UNC Charlotte Phase 16

Addendum #4

Revision Narrative

2021-09-08

E-200S

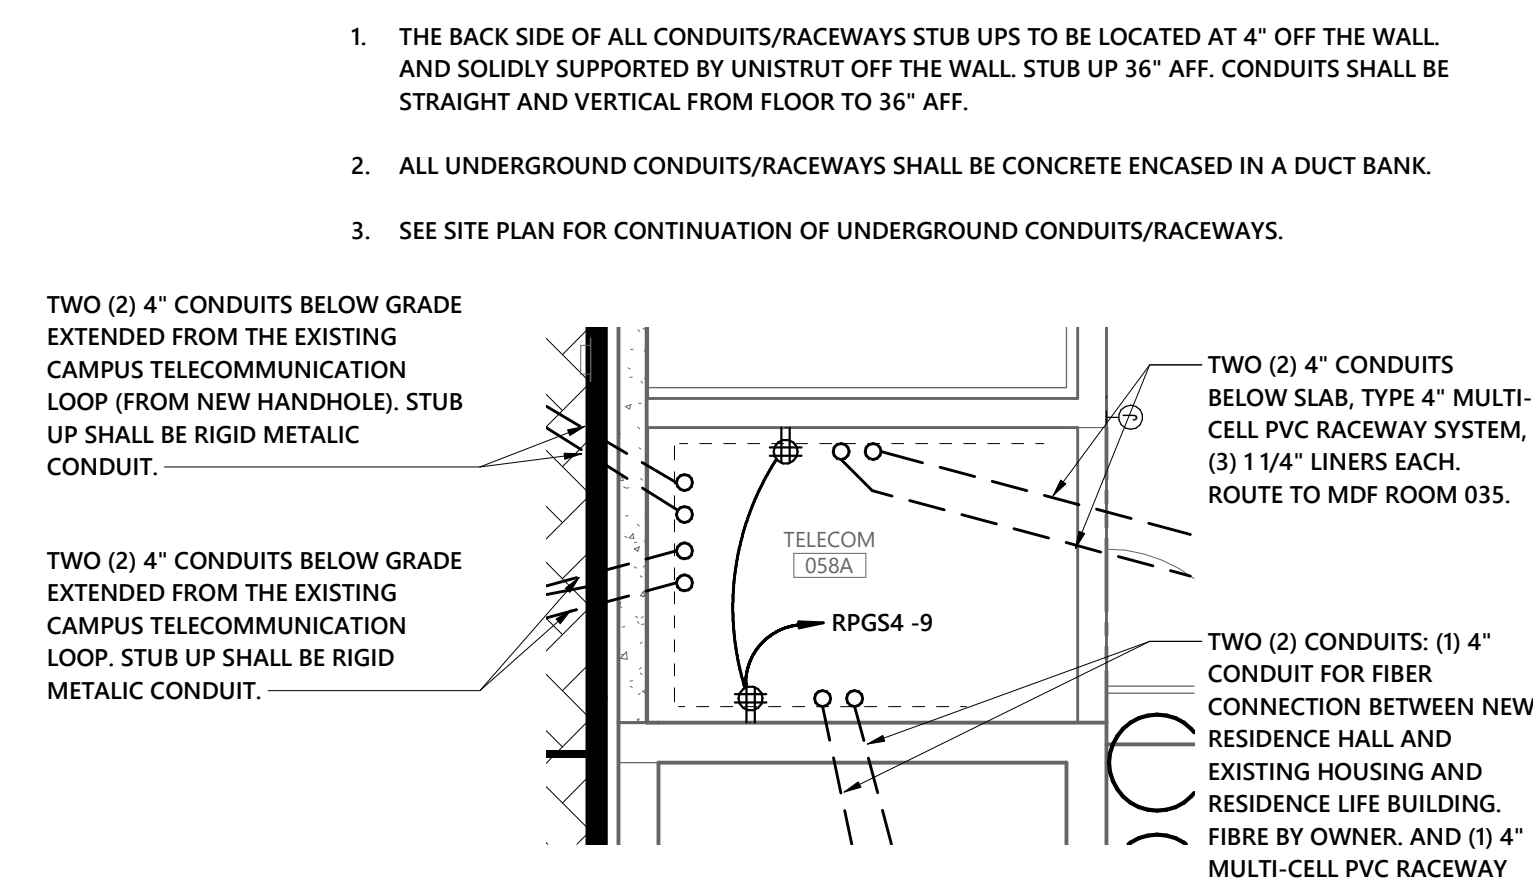
E-200S - Removed conduit, conduit notes updated.

E-200S-A

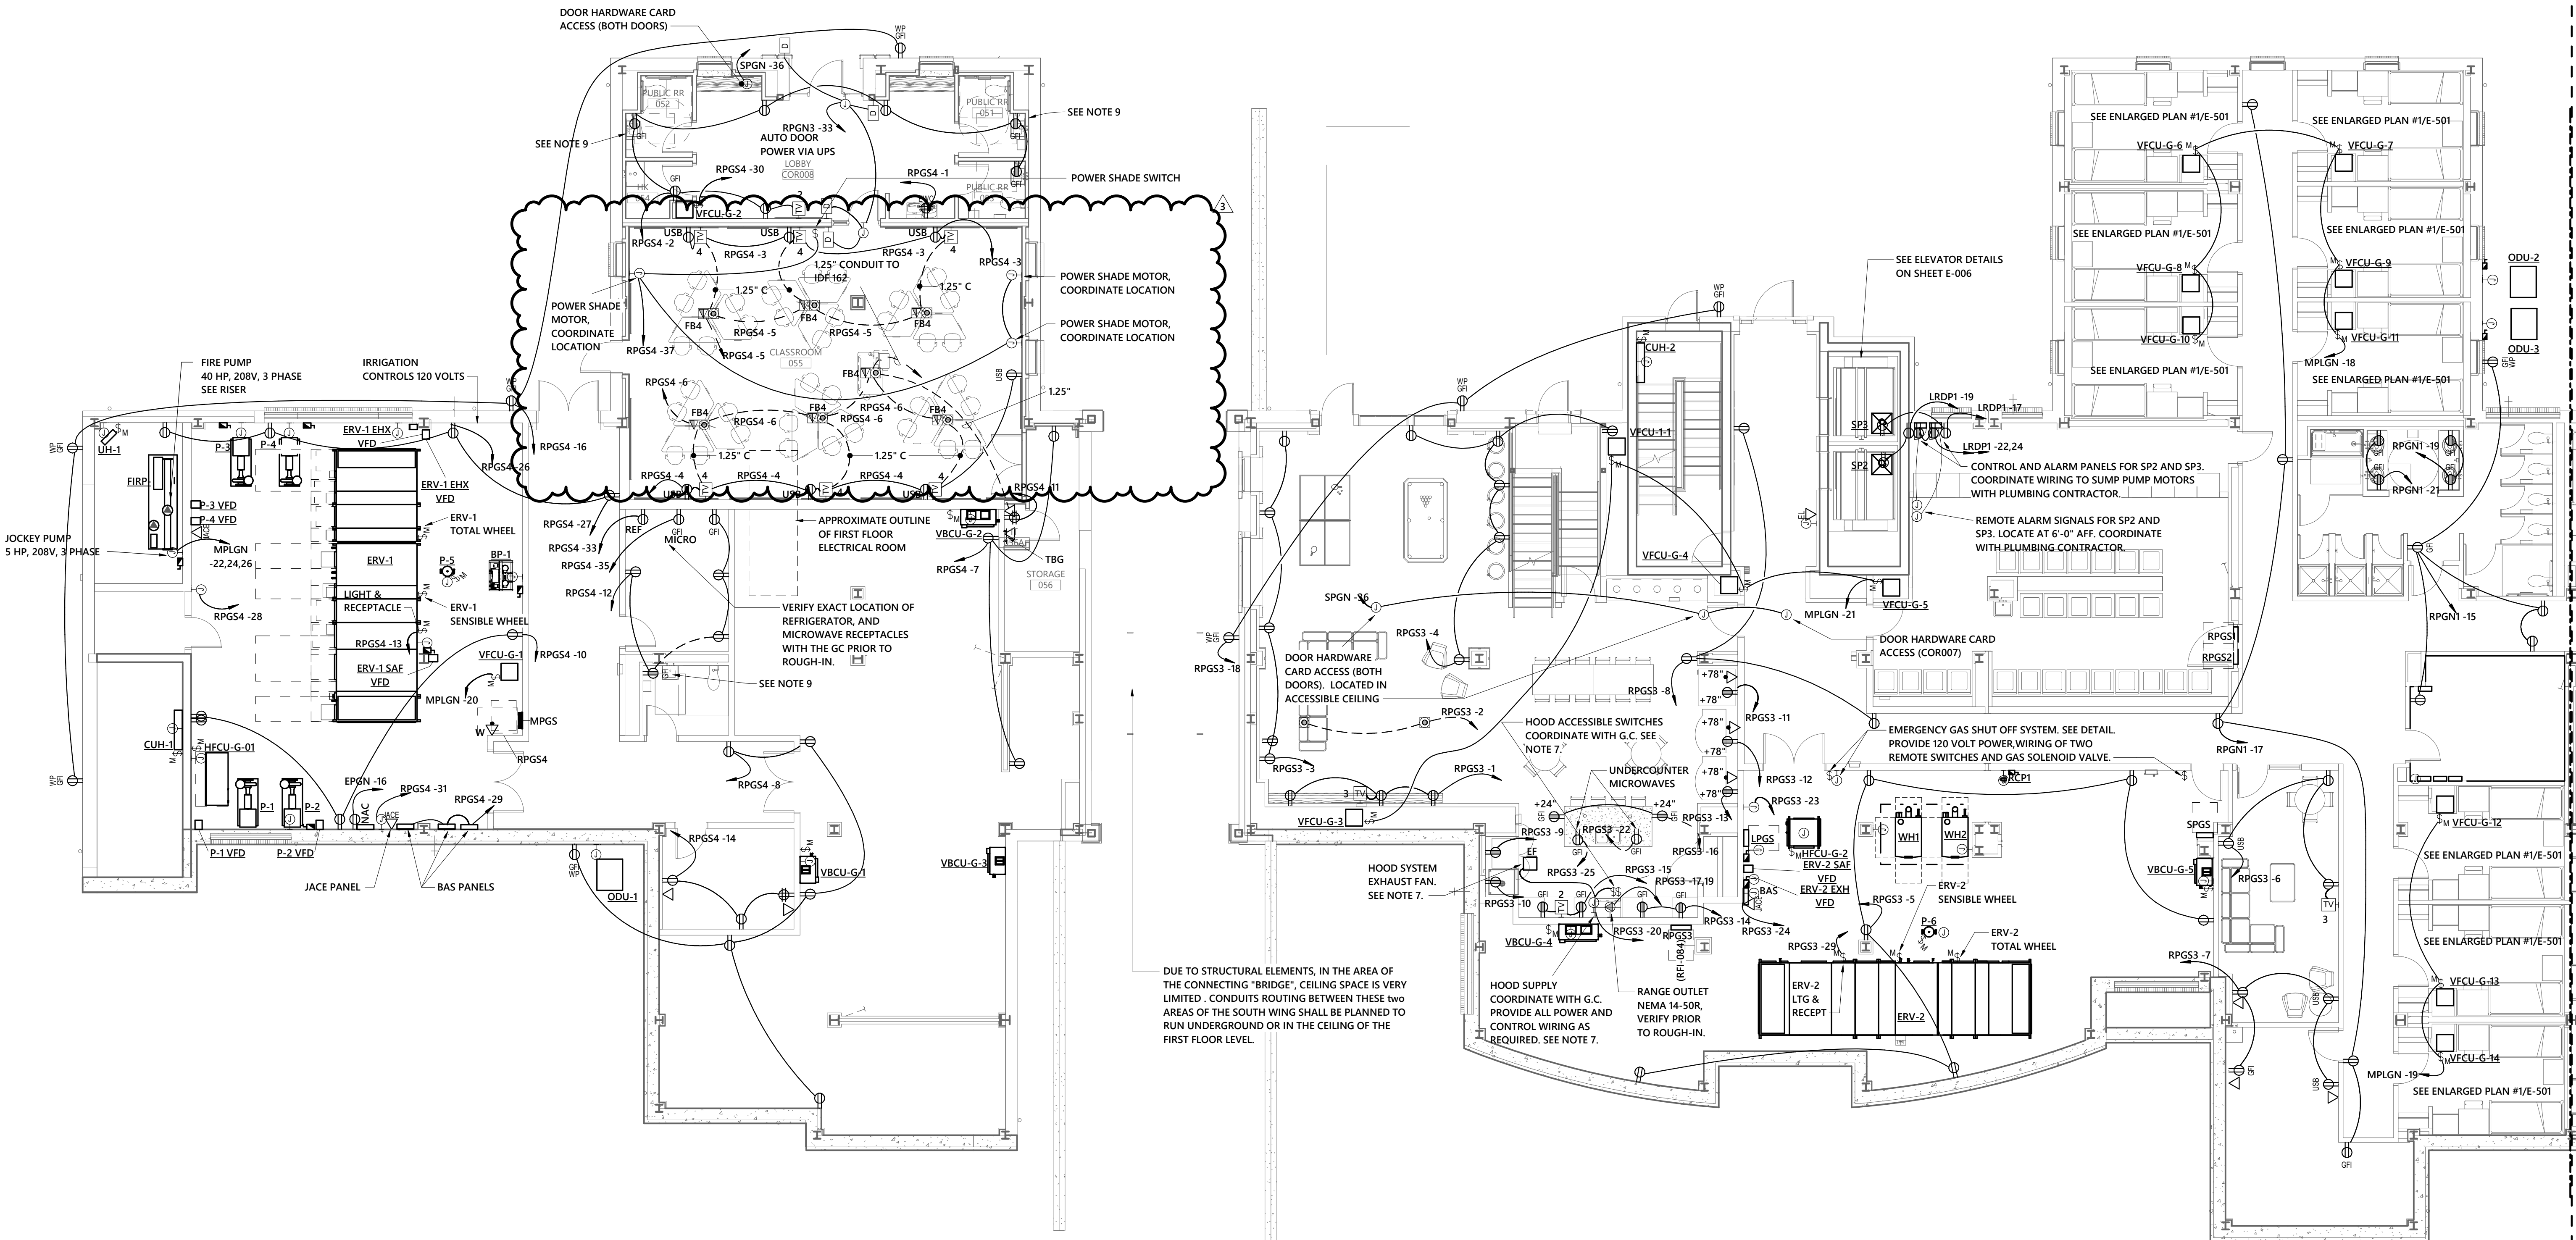
E-200S-A - Conduit and notes updated.

E-201N
 Optima # 18-0001 Sheet 17 of 84
 BM 360//18NCC016 RH PHASE XVI/18-0001_UNCC-XVI A-MEP-V20.rvt

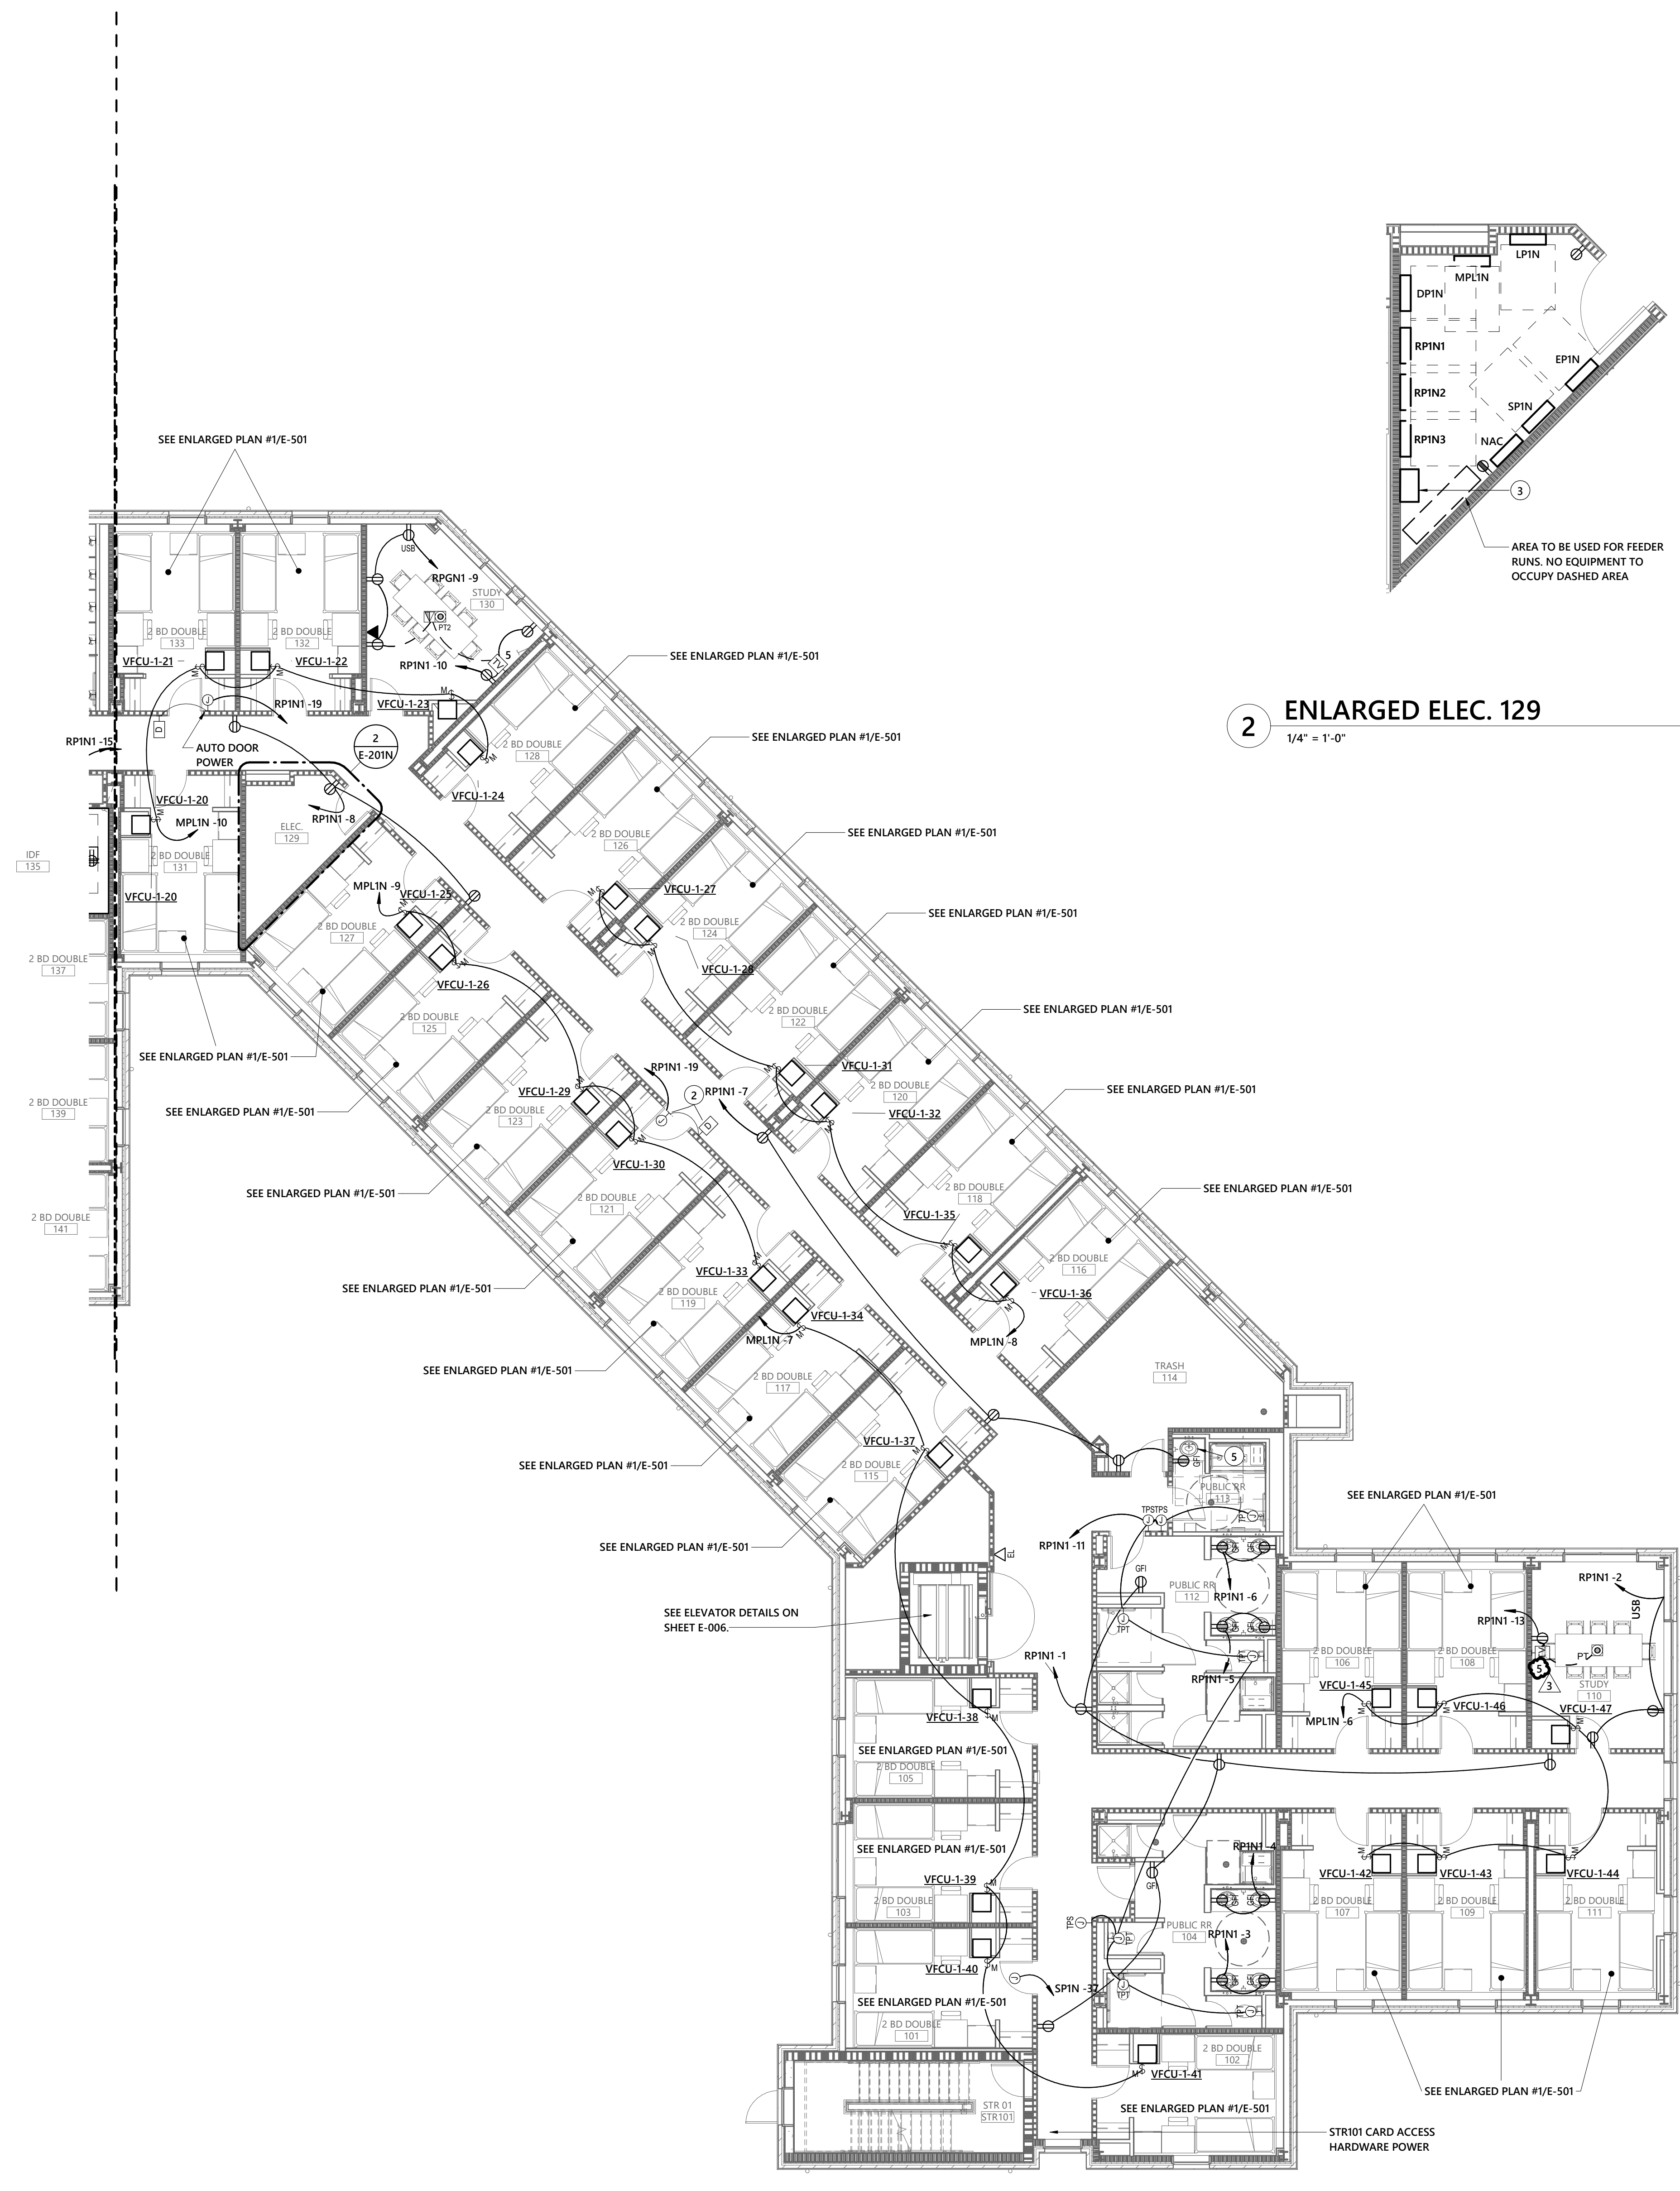
E-201N - Changed TV type.
